ENGINE - H.P. COMPRESSOR STAGE 7 AND 8 ROTOR PATHS WITH REDUCED SPRAYED THICKNESS
ABRADABLE LININGS - CATEGORY CODE 6 - MOD.ENG-72-0030

V2500-ENG-72-0030

SERVICE BULLETIN

Location of H.P. compressor stages 7 and 8 rotor paths
Fig.1

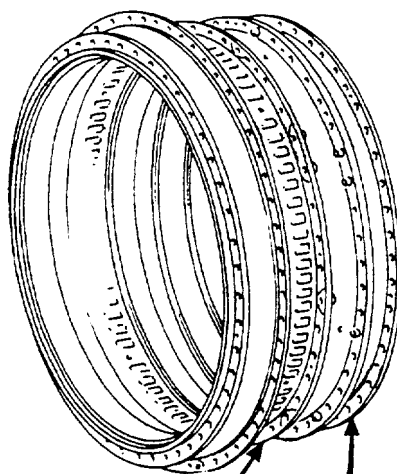
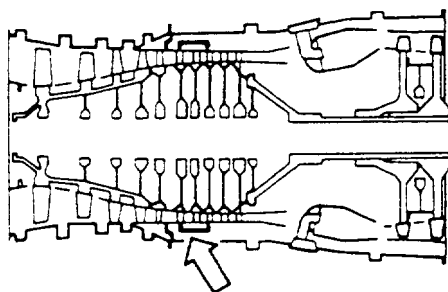
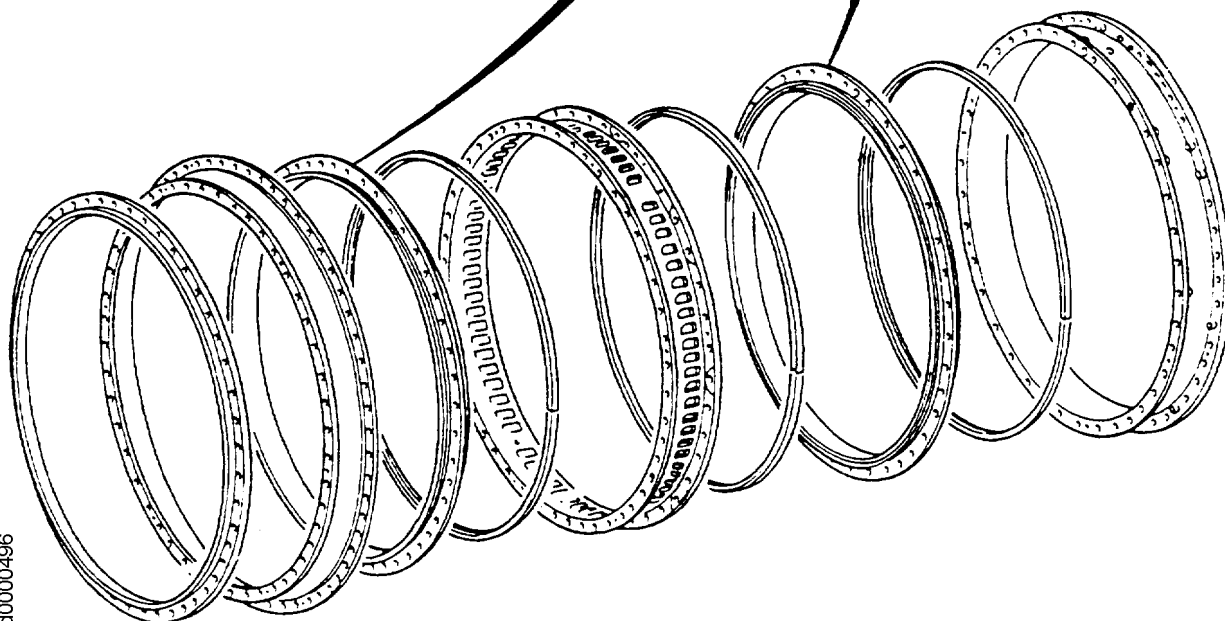
REMOVE 6A3652 RING (1 off) AND
INSTALL 6A4102 RING (1 off)

REMOVE 6A3651 RING (1 off) AND
INSTALL 6A4101 RING (1 off)

Modification of HP Compressor Stage 7 Rotor Path
Fig.2

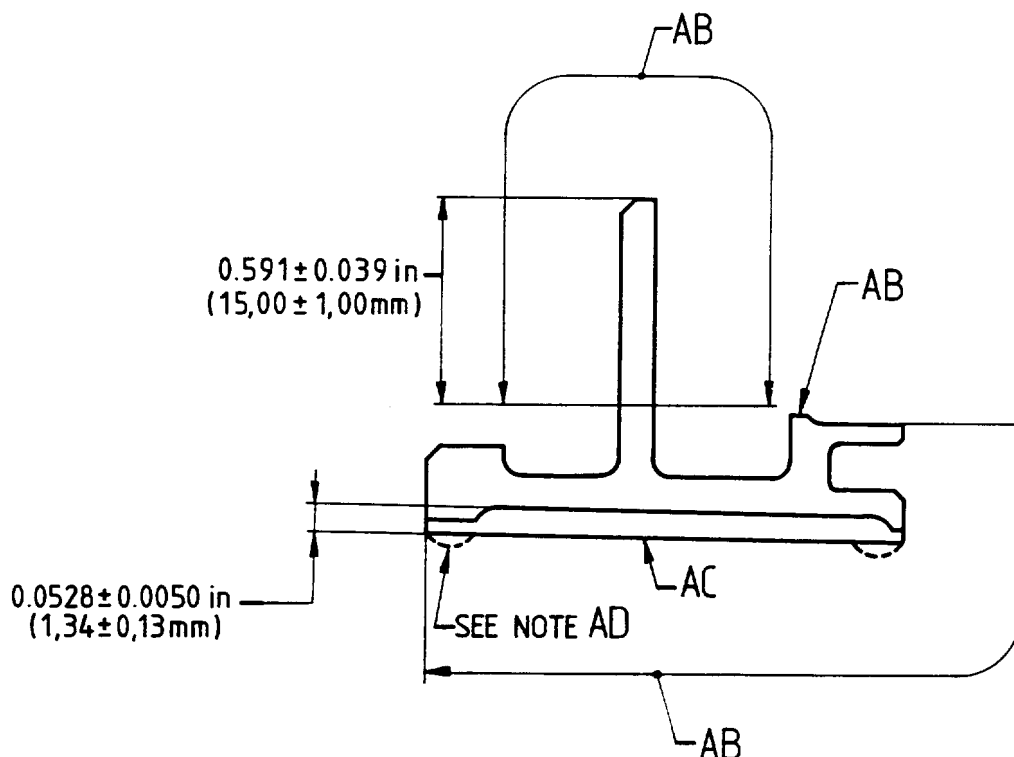
THE REMOVAL OF THE SEAL MATERIAL FROM
THE STAGE 7 COMPRESSOR ROTOR PATH

MACHINE WHERE SHOWN ✓

REMOVE THE SHARP EDGES $0.012 \pm 0.008 \text{ in}$ ($0,30 \pm 0,20 \text{ mm}$)

MACHINED SURFACE FINISH TO BE 250 MICROINCHES (6,30 MICROMETRES)

| (b) Assemble rotor path ring onto turning fixture and machine to remove abradable lining. | Machine to remove lining. Figure 2 or 4 You must not remove material from the ring. |

Modification of HP Compressor Stage 7 Rotor Path Abradable Lining
Fig.3

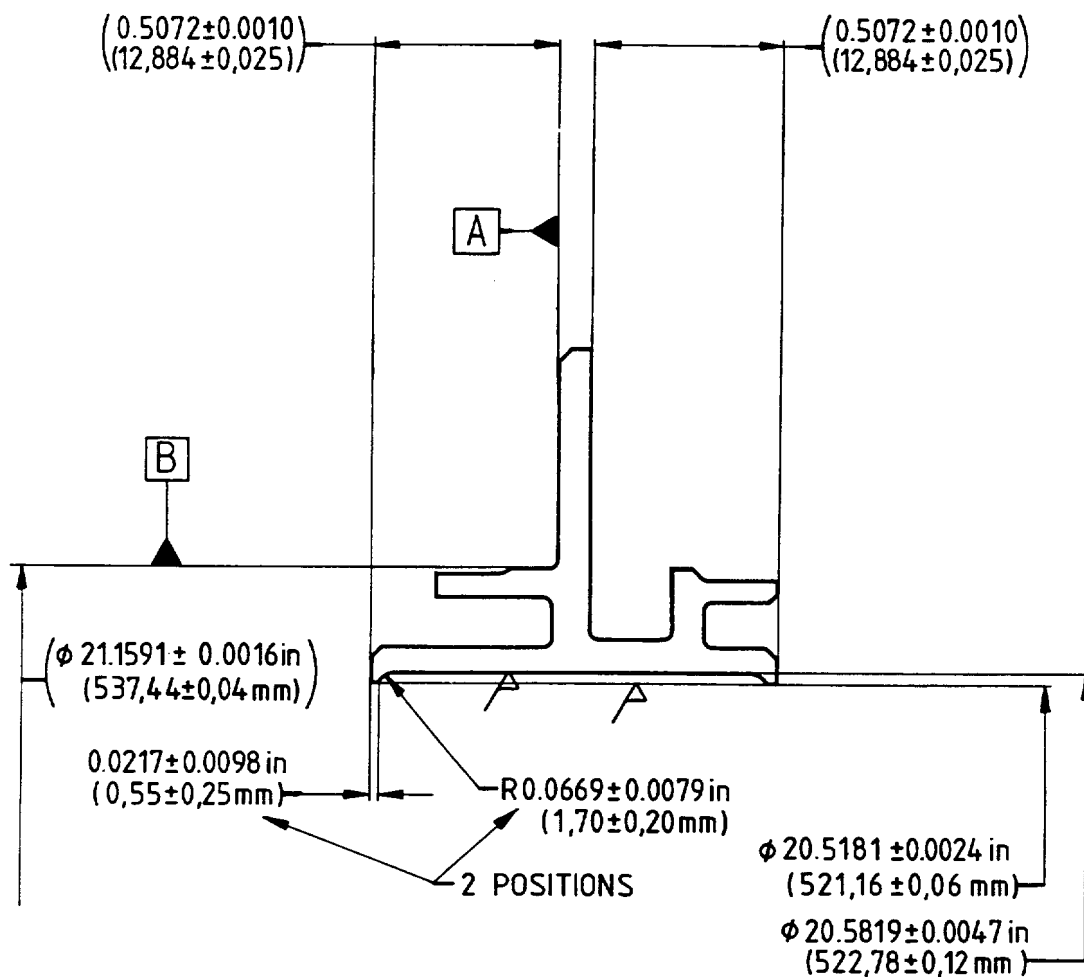
THE REPLACEMENT OF THE SEAL MATERIAL IN
THE STAGE 7 COMPRESSOR ROTOR PATH

MAKE GOOD ALL DAMAGE TO ENAMEL AS GIVEN IN TEXT.

DO NOT LET THE ENAMEL TOUCH THE AREAS SPECIFIED AB OR GO INTO THE HOLES.

APPLY THE SEAL MATERIAL AS GIVEN IN THE TEXT ON THE AREA SPECIFIED AC.

IT IS PERMITTED TO MAKE SURFACE NOT SMOOTH.

Figure 3 or 5. Use CoMat 03-235 or CoMat 03-236. Remove covers when spraying is completed. |

Modification of HP Compressor Stage 8 Rotor Path Abradable Lining
Fig.4

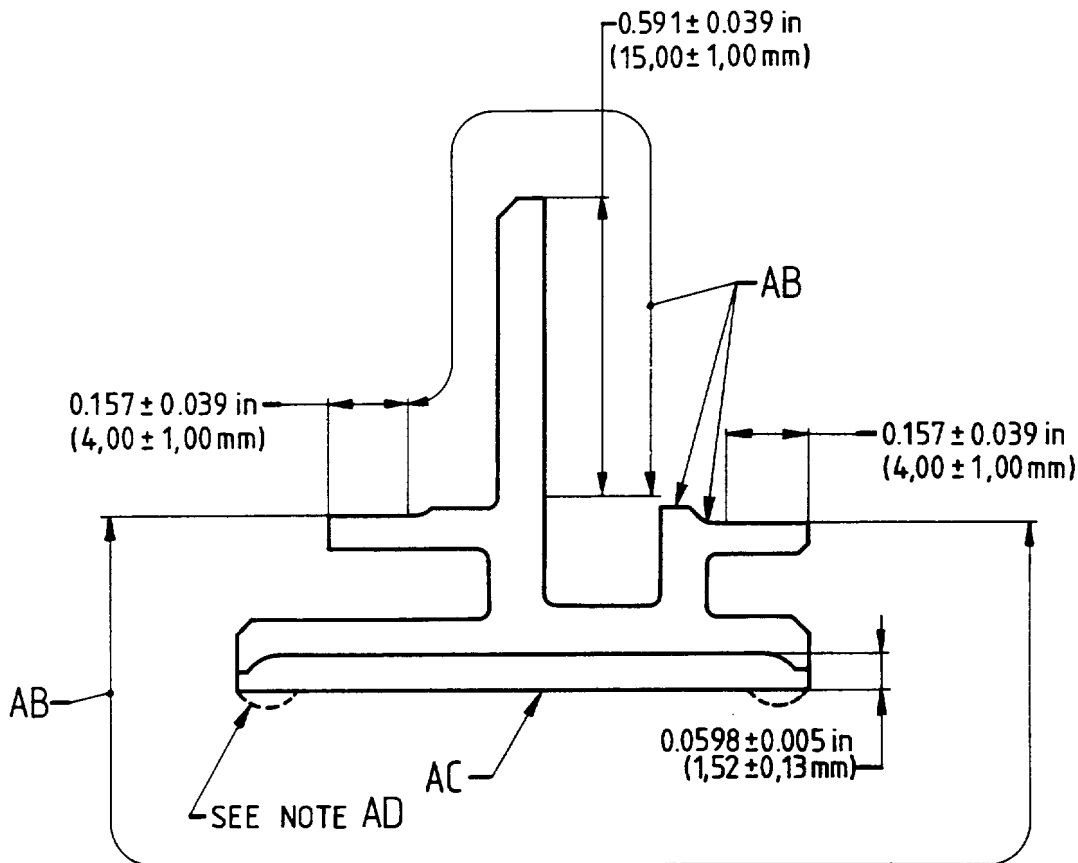
THE REMOVAL OF THE SEAL MATERIAL FROM
THE STAGE 8 COMPRESSOR ROTOR PATH.
